R11SU

FMVSS 221 Joint Strength Noncompliance Adhesive Omitted on 20 Gauge Outside Side Panels

Models Affected: 2010 Model Year All American (D3) Model School Buses with Optional 20 Gauge Outside Side Panels

Photo 1
Spacing from bottom edge of window line rub rail to floor line.

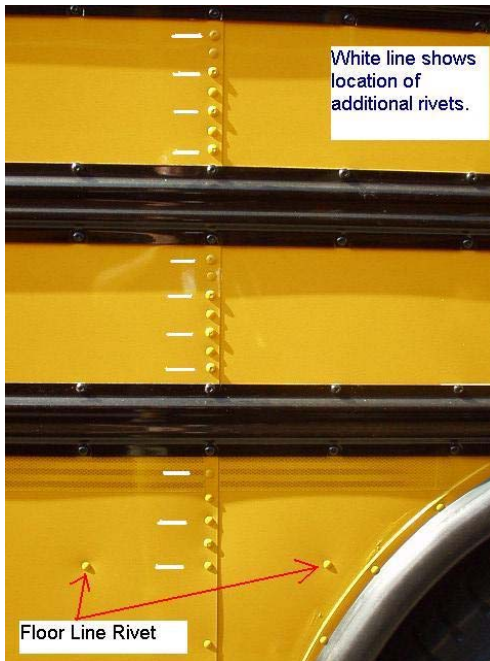
- Using a 17/64" drill bit, drill additional rivet holes at each outside side panel joint as indicated by white dash line in Photo #1 below. A drill stop set at 1/2" (0.50) must be used to prevent possible damage to wires in bow cavities. Be sure holes are evenly spaced between existing rivets and that holes stay in line with existing rivets.

- Install part number #01854397 Rivet, Blind, .25 Dia, .38 grip, in each hole drilled using a rivet gun/tool.
- On the street side of the bus, remove the stop arm to allow installation of the additional rivets in beltline area, then reinstall stop arm.
